# Model Administrative Change Notice

<b>1. Document Number:</b>	MDL-NBS-HS-000008	<b>2. Revision:</b>	02	<b>3. ACN:</b>	01
<b>4. Title:</b>	Radionuclide Transport Models Under Ambient Conditions				
<b>5. No. of Pages Attached</b>	17

Figure A-59b. Empirical Cumulative Distribution for Thorium Sorption Coefficients on Devitrified Tuff

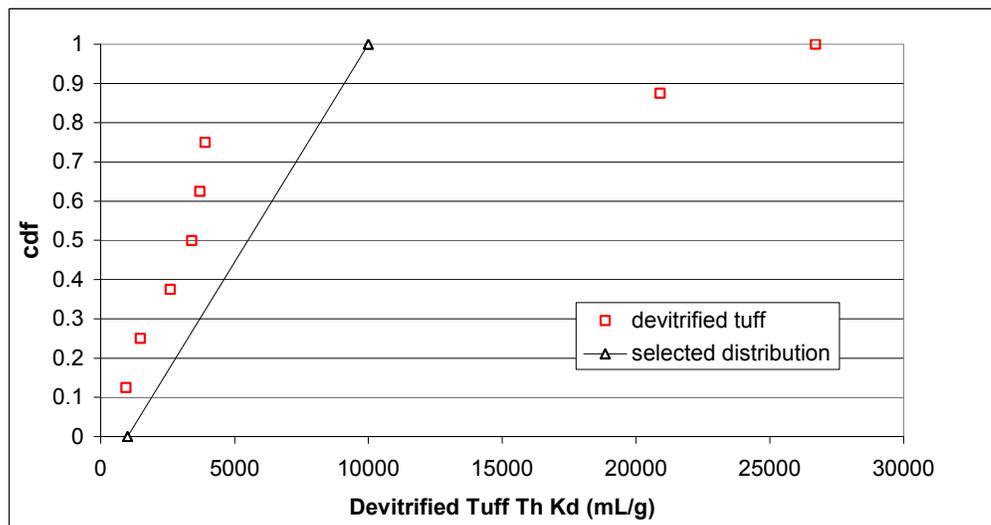
A-73	<p>Citation update</p> <p>Figure A-59b “Empirical Cumulative Distribution for Strontium Sorption Coefficients on Devitrified Tuff”, change the description for this figure to read:</p> <p><b><i>“Empirical Cumulative Distribution for Thorium Sorption Coefficients on Devitrified Tuff”</i></b></p> <p>This error was identified in CR 5200</p>

Figure A-59d. Empirical Cumulative Distribution for Thorium Sorption Coefficients on Vitric Tuff

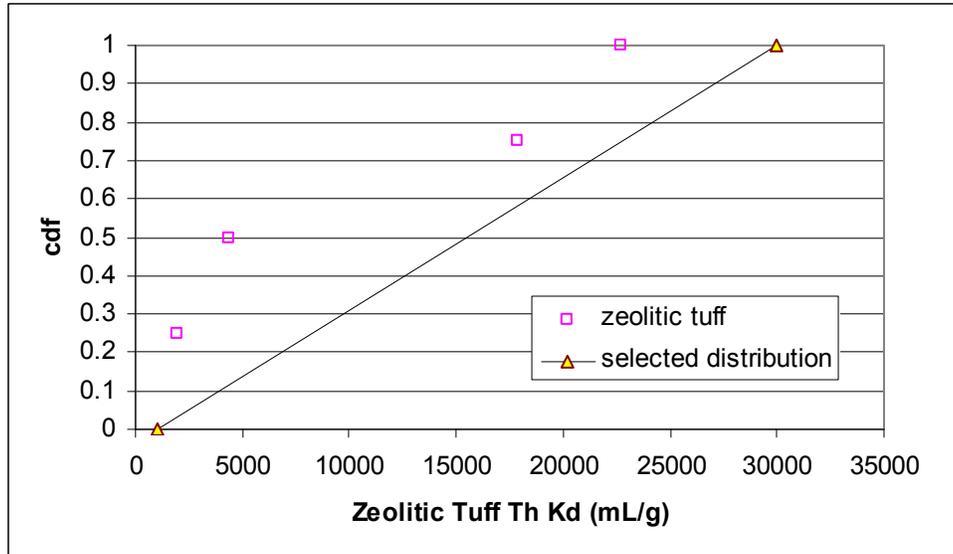
A-74	<p>Citation update</p> <p>Figure A-59d “Empirical Cumulative Distribution for Strontium Sorption Coefficients on Vitric Tuff”, change the description for this figure to read:</p> <p><b><i>“Empirical Cumulative Distribution for Thorium Sorption Coefficients on Vitric Tuff”</i></b></p> <p>This error was identified in CR 5200</p>				
I-1 through I-5	<p>Typographical error</p> <p>Footnote on pages I-1 through I-5, change:</p> <p>MDL-NBS-HS-000008 REV</p> <p>To</p> <p><b><i>MDL-NBS-HS-000008 REV 02</i></b></p> <p>This change was self-identified</p>

Figure A-59c. Empirical Cumulative Distribution for Thorium Sorption Coefficients on Zeolitic Tuff

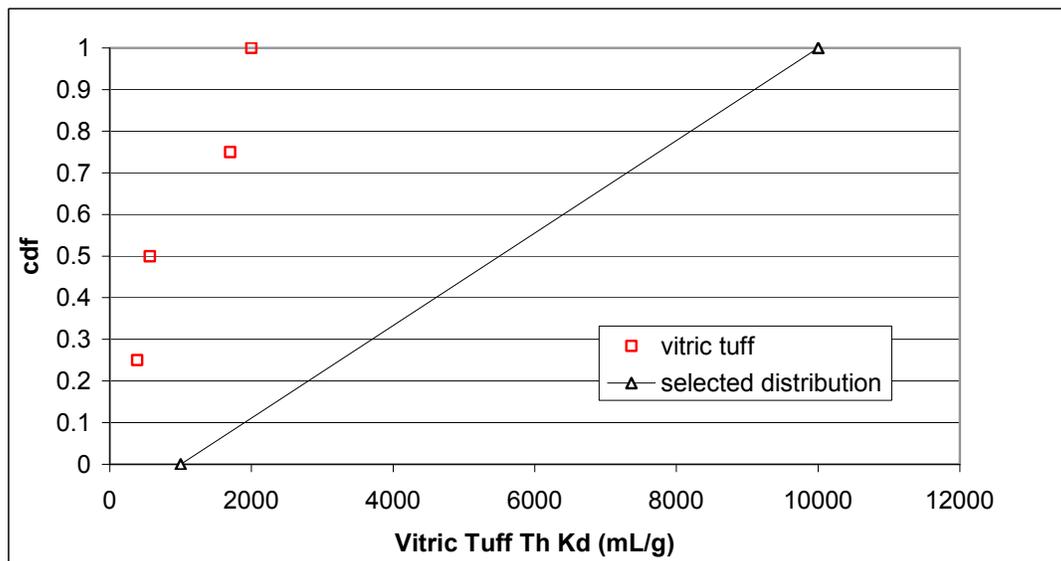
<b>1. Document Number:</b>	MDL-NBS-HS-000008	<b>2. Revision:</b>	02	<b>3. ACN:</b>	01
<b>4. Title:</b>	Radionuclide Transport Models Under Ambient Conditions				
A-74	<p>Citation update</p> <p>Figure A-59c “Empirical Cumulative Distribution for Strontium Sorption Coefficients on Zeolitic Tuff”, change the description for this figure to read:</p> <p><b><i>“Empirical Cumulative Distribution for Thorium Sorption Coefficients on Zeolitic Tuff”</i></b></p> <p>This error was identified in CR 5200</p>				
A-74	<p>Change to figure</p> <p>Figure A-59d “Empirical Cumulative Distribution for Strontium Sorption Coefficients on Vitric Tuff”. In the “old” version, one point that had data for devitrified tuff was mistakenly classified as vitric tuff. <b><i>Delete one point which is not vitric tuff.</i></b></p> <p>Note: This figure is used for illustration only. The change does not affect the product output</p> <p>This error was identified in CR 5732</p>
